| <b>Project Name:</b>       | Land to the side of 1 Highfield Parade, Waterloooville |
| <b>Document Reference:</b> | 020.01027/HRN/1                                        |
| <b>Document Name:</b>      | Technical Note                                         |

1.1 This Highways Response Note (HRN) has been prepared by Paul Basham Associates in response to comments made by Hampshire County Council (HCC) in their role as the local highway authority, in relation to the proposed scheme for *'The construction of a new two-bedroom dwelling on land to the side of 1 Highfield Parade, with vehicular and pedestrian access taken from Burnside with associated parking, refuse and cycle store'* (application reference: APP/25/00390) at Land to the side of 1 Highfield Parade, Waterloooville. The latest site plan is attached within **Appendix A**.

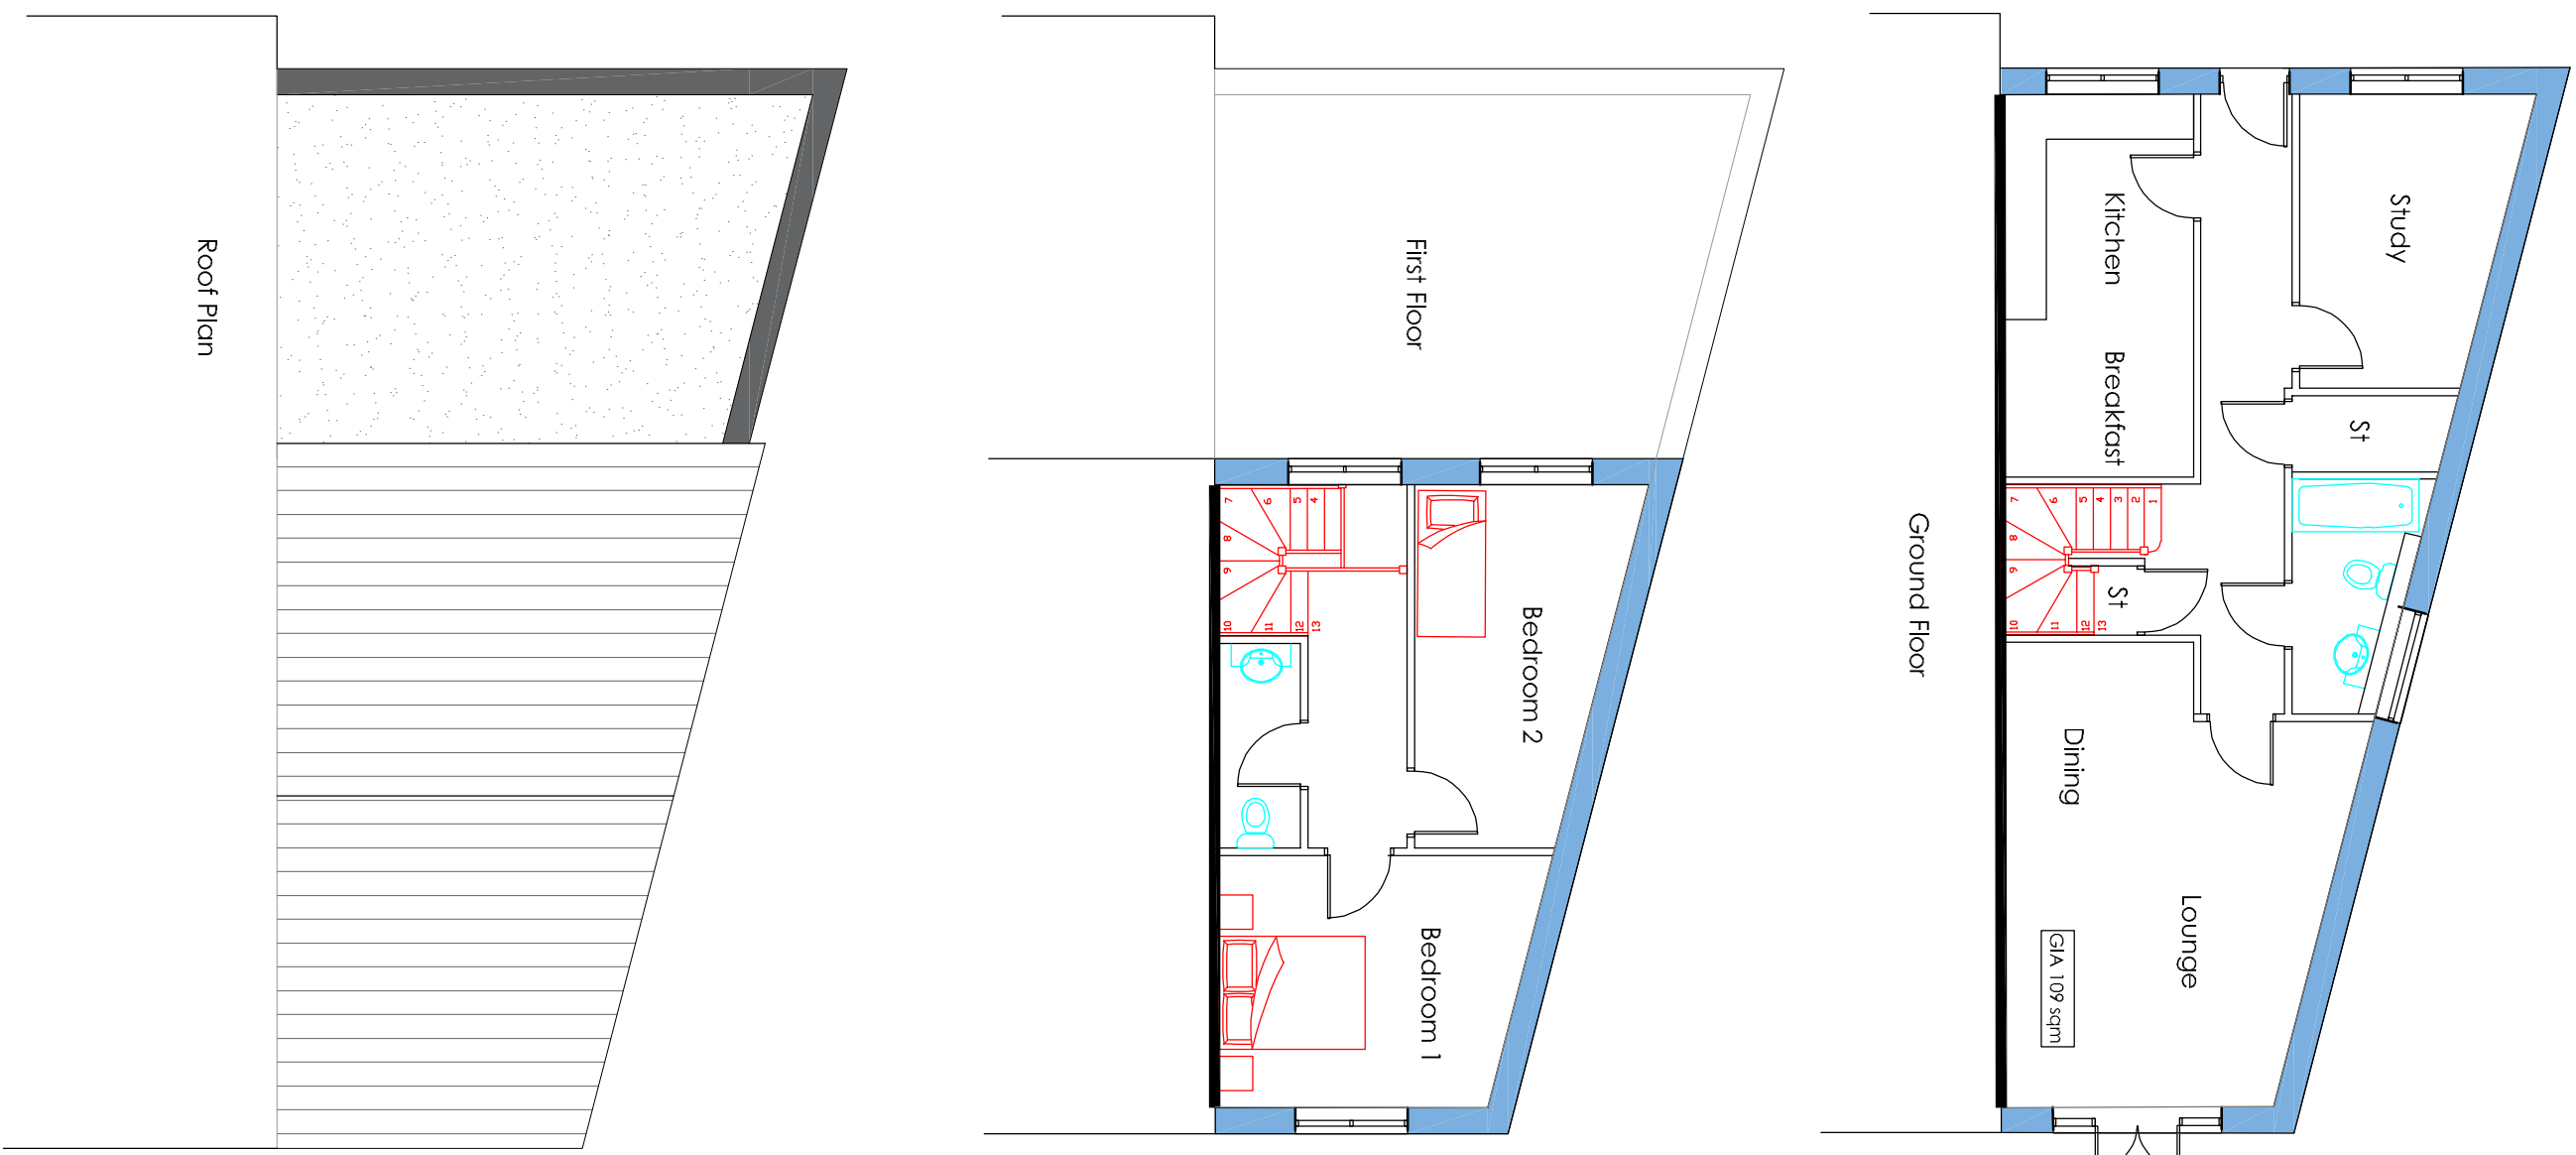
*'Access rights over the Burnside access link have not been confirmed. Specifically the Highway Authority require clarity of the proposed driveway access details and how this is proposed to tie-in with the existing footway either side of the current bellmouth, ensuring safe and appropriate provision for all users, within land in the applicants control whilst maintaining the current highway boundary. A plan detailing the proposed arrangement, land ownership and Highway Boundary information is therefore required.'*

- 2.7 Although the access is to remain as existing, a visibility splay assessment has also been conducted to ensure that there would be no reliance upon third-party land to achieve a safe and suitable arrangement for the single dwelling. This visibility splay assessment has been conducted based on Manual for Streets (MfS) guidelines for speeds of 20mph with 2.4m x 25m splays drawn in both directions from the access. It is noted that the local road network is subject to a 30mph speed limit; however, considering the residential nature of Burnside, the high presence of on-street parking along the carriageway and the proximity of the access to the Burnside/Highfield Avenue junction, speeds are expected to be significantly less than 30mph and more in line with 20mph. In the secondary direction, due

to the on-street parking bays, additional visibility splays have been drawn for 2.4m x 25m to the carriageway centreline and 2.4m x 7.6m to the edge of the marked bays. There would also not be any increase in vehicle movements using this access compared to the existing situation.

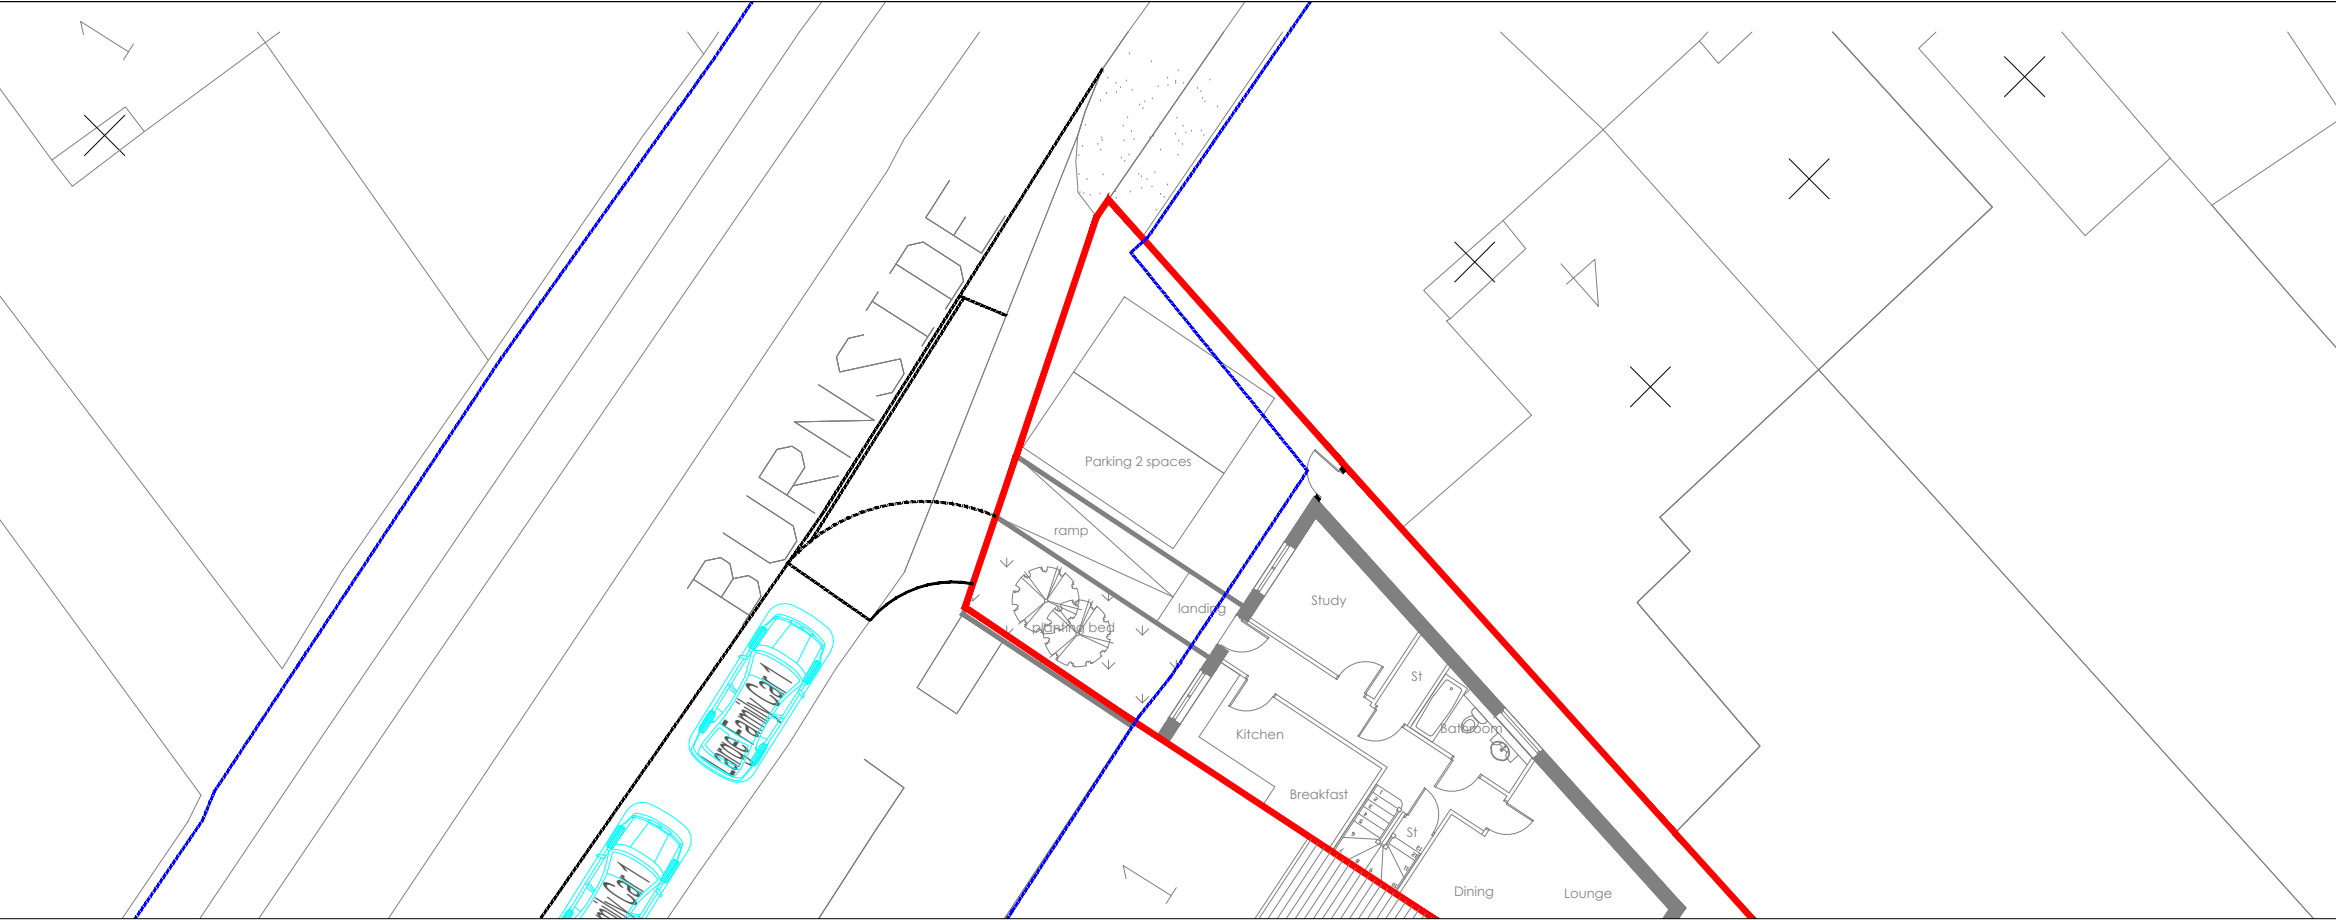
*'The applicant has now provided tracking information (Drawing CFA-FULL-01-Rev-01) for a commercial van and fire appliance. These vehicles can manoeuvre appropriately within the site, however no swept path is provided for rigid HGV's which may be required for retail servicing.'*

*'Furthermore, details regarding refuse collection for both the residential and retail uses accessed via the apron have not been provided which potentially access the apron.'*

- 2.2 As requested by the local highway authority, swept path analysis has been undertaken for a rigid vehicle (12.0m length) entering, turning within and exiting the apron for the commercial units via the existing access on Meadway. As demonstrated in **Appendix C**, swept path analysis for a 12.0m rigid vehicle has been sufficiently completed for the above manoeuvre, confirming that servicing for the retail units can continue to take place to the rear via the apron from Meadway.

- 2.4 To confirm, refuse collection for the proposed dwelling will take place on-street along Burnside in line with the existing operation along the road for all other dwellings. The refuse store for the dwelling will be located to the rear of the property within the garden space, with the drag distance for residents to position their bins to the front of the property a maximum of 30m in line with Manual for Streets (MfS) guidelines. Refuse collection for the existing retail units and apartments will continue as per the existing arrangement. If required to occur via the apron, swept path analysis of the HCC refuse vehicle has been conducted to ensure refuse collection will all uses can be competed suitably from Meadway. As also demonstrated within **Appendix C**, the HCC refuse vehicle is able to enter,

turn and exit the apron via the existing Meadway access in a forward gear suitably to undertake refuse collection.
